**SOIL/SITE EVALUATION
 for ON-SITE WASTEWATER SYSTEM**

SURVEY FOR: PROPOSED PLOT PLAN - LOT - 186 WOODSHIRE S/D, PHASE - FIVE		JOB NO. 09380	
TOWNSHIP ANDERSON CREEK		COUNTY HARNETT	
STATE: NORTH CAROLINA		DATE: JULY 07, 2009	
ZONE RA-20R	WATERSHED DISTRICT	TAX PARCELS: 206	
BENNETT SURVEYS, INC. 1642 CLARK RD., ULLINGTON, N.C. 27546 (919) 893-5252		C-1060	
SCALE: 1" = 40'		SURVEYED BY:	FIELD BOOK
CHECKED & CLOSURE BY:		DRAWN BY: RVB	DRAWING NO.
			09380

Re: Hydraulic conductivity (Ksat) analysis for subsurface waste disposal, Lot 186,
Woodshire Subdivision (Phase 5), Harnett County, North Carolina

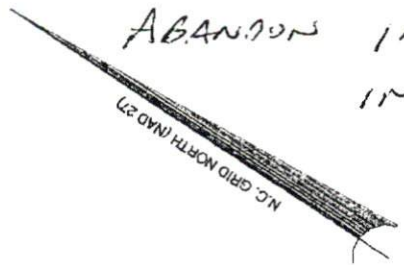
11/4/09 House 10' closer than permitted.

Met with GRAHAM & OLIVER on site will use

AREA BETWEEN INITIAL LINES FOR REPAIR

ABANDON INITIAL SYSTEM WHEN REPAIR INSTALLED
